ARTC EIS RESPONSE

A stakeholder's response to Australian Rail Track Corporation Ltd.'s Environmental Impact Statement
Application Number: SSI-10055, on behalf of affected residents

Figure 1 - figure 25 on page 63 of Tech Paper 7 Operational Noise and Vibration (Rail)

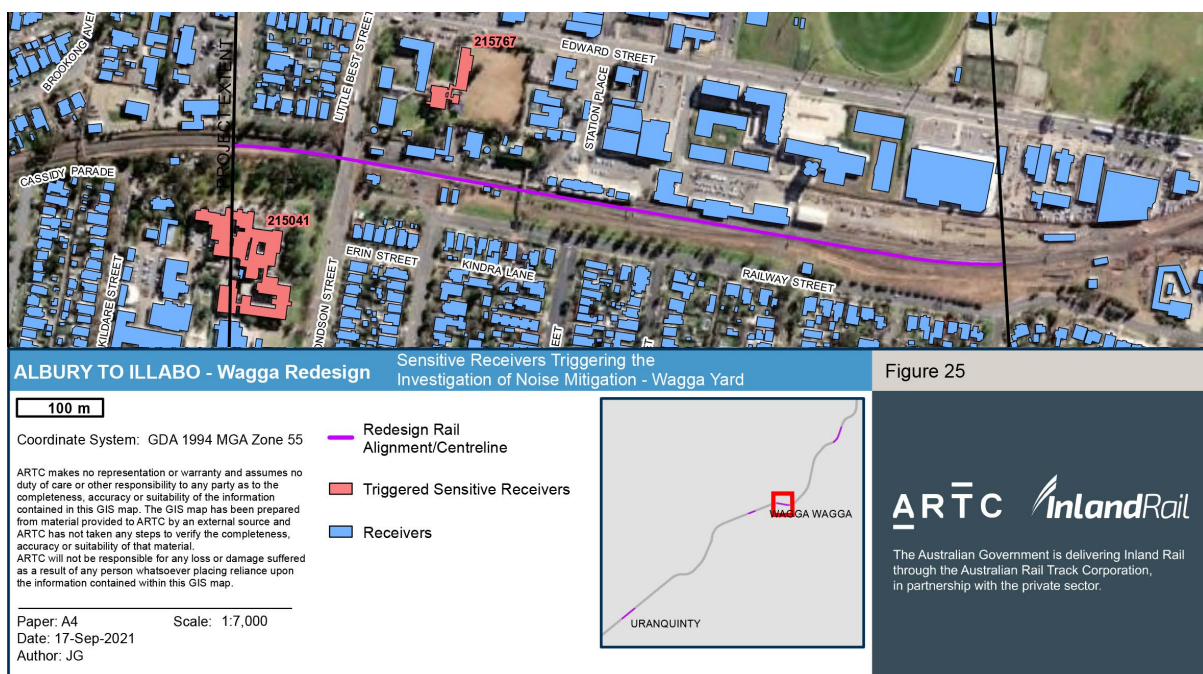
Figure 25 from [Technical paper 7 - Operational Noise and Vibration \(rail\)](#) identifies Kildare Catholic College as a "triggered sensitive receiver" with the nearest building being approximately 60m from the rail boundary. The houses along Donnelly Avenue (North of Kildare Catholic College) are only listed as receivers, and not considered *sensitive*. All the buildings on this street are residential and have an average distance of approximately 25m from the rail boundary.

Figure 3 - figure 25 on page 63 of *Tech Paper 7 Operational Noise and Vibration (Rail)*

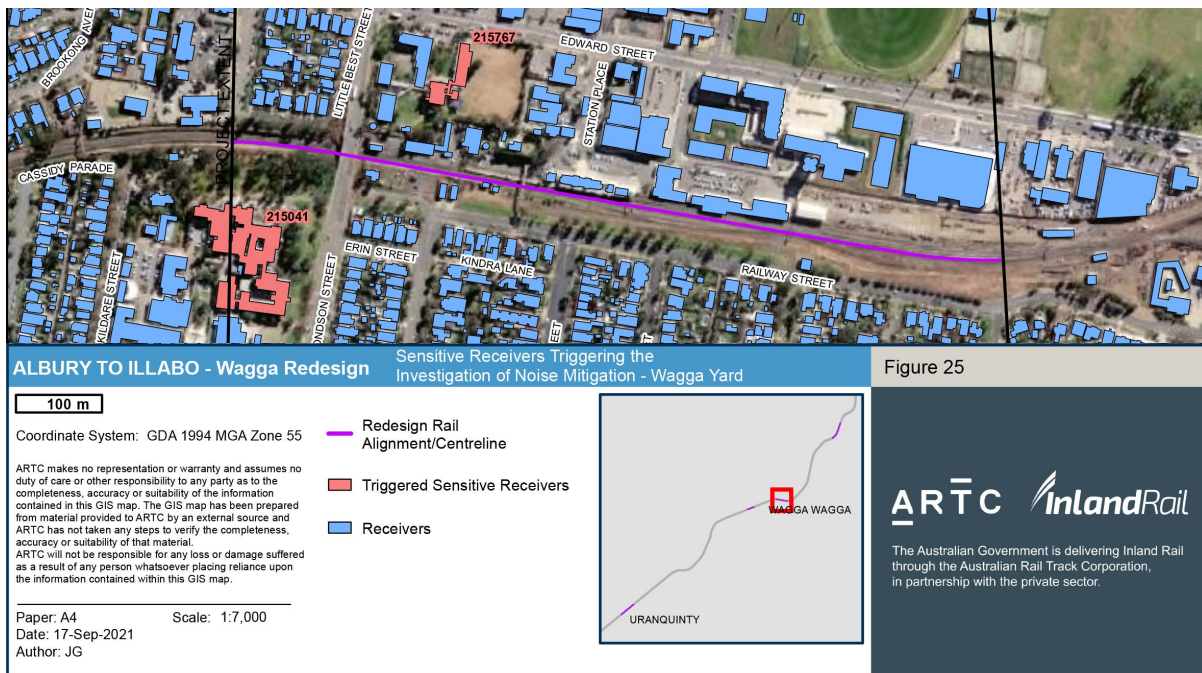
How is this so? Looking at the map and at figure 25 on page 63 of *Tech Paper 7 Operational Noise and Vibration (Rail)* shows that residences were never considered as triggered sensitive receivers, despite the definition of sensitive receivers.

Quoting again from page 24 of the EIS summary, “Two non-residential receivers, being the South Wagga Public School near the Wagga Wagga Yard clearances and the Kildare Catholic College near the Edmondson Street bridge, are predicted to experience operational rail noise exceedances.” Look at the diagrams and take note of the residential properties that are between those two non-residential receivers.

Figure 8 Predicted change in daytime LAeq(15hour) noise levels- Year 2025

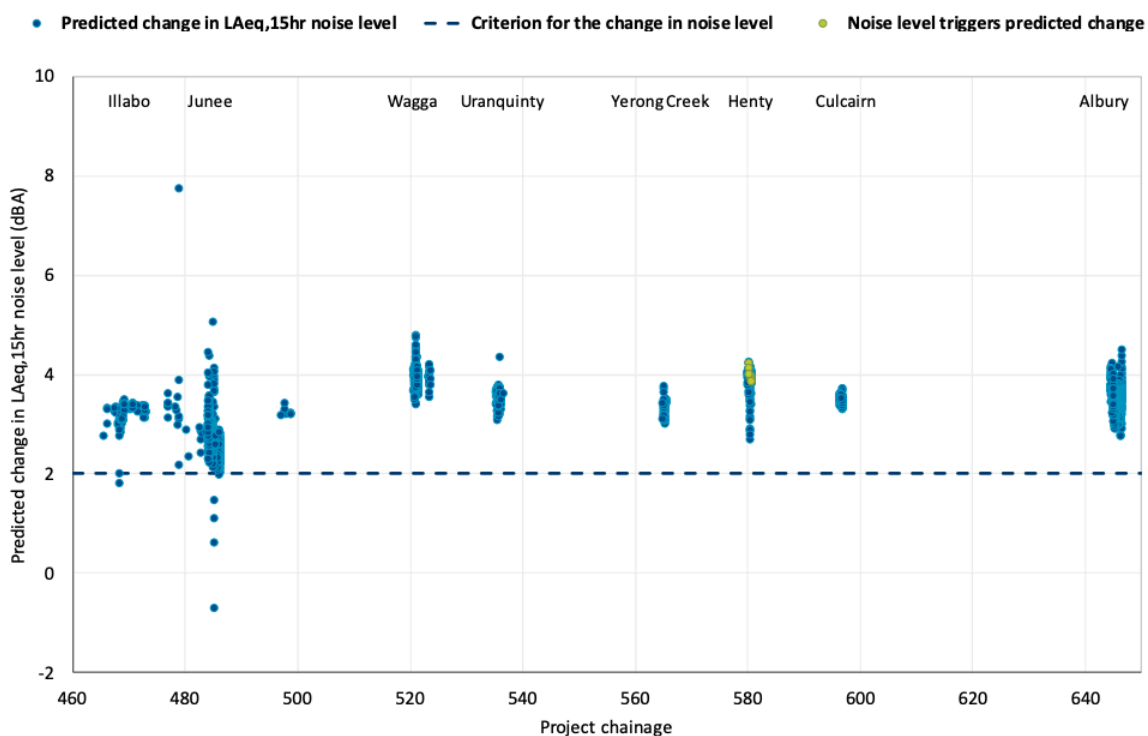
This means, in actual fact, that for my address 12 Donnelly Avenue Wagga Wagga, a change in 4dB during the day is equivalent to greater than a 250% increase in noise (using the formula $P = (10^{X/10}) * 100$).

This information buried in technical papers makes the EIS and EIS summary less approachable for a lot of stakeholders. Understandably the information needs to be presented, so no comments on that aspect necessarily, but if real information is being obscured by cherry picking data, then I would think that this needs to be investigated a lot further and deeper. I have quite limited time to read a 4000+ page series of documents in the limited feedback window. I can only scratch the surface on these documents, and if erroneous errors and omissions such as the ones above are found by me, then surely there are a lot more where that came from.

FIGURE F3-1 IAP2 SPECTRUM FOR PUBLIC PARTICIPATION

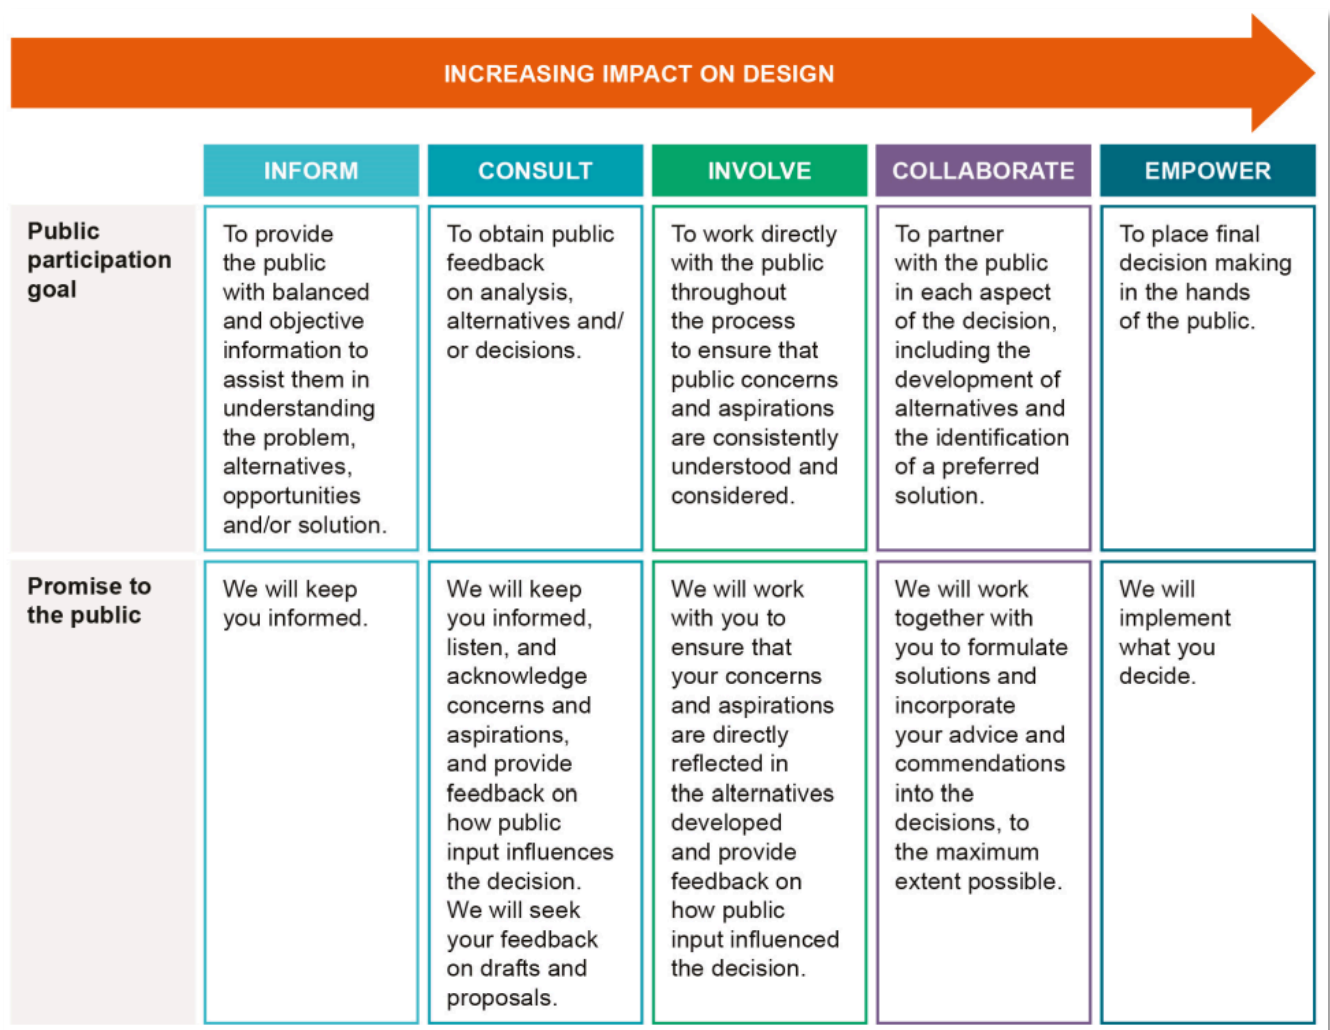
It seems ARTC have skipped a few steps in their "spectrum for public participation" figure. (figure F3-1IAP2).

I reference this table, as the Landowners and site neighbours summary of engagement for Wagga Wagga (F5.1.4)^{xi} contradicts the table and Section 3.2 of appendix F. I'll summarise:

How are geo-targeted online and social-media ads *equitable* (F3.2)? This was the *only* way that ARTC decided to communicate with stakeholders regarding the 30 per cent, 70 per cent and 100 per cent community information sessions. This is NOT equitable, inclusive, or accessible. This goes against the ARTC's own engagement principals outlined in section F3.2.
